Modifications Notices

Safety Relays

No. 2013110AE

Modification Notice of Safety Relay Type G7SA series shaft material and product marking.

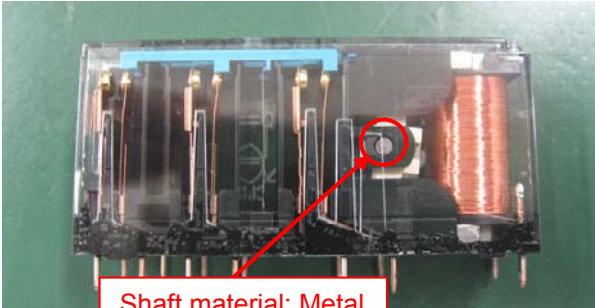
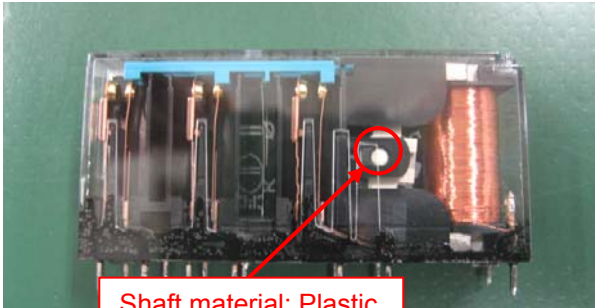
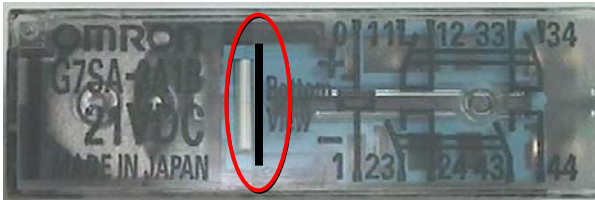
Before the change	After the change
Shaft material: Metal  Shaft material: Metal Product marking: line none.   (Product marking before change)	Shaft material: Plastic  Shaft material: Plastic Product marking: In line.   (Product marking after change)
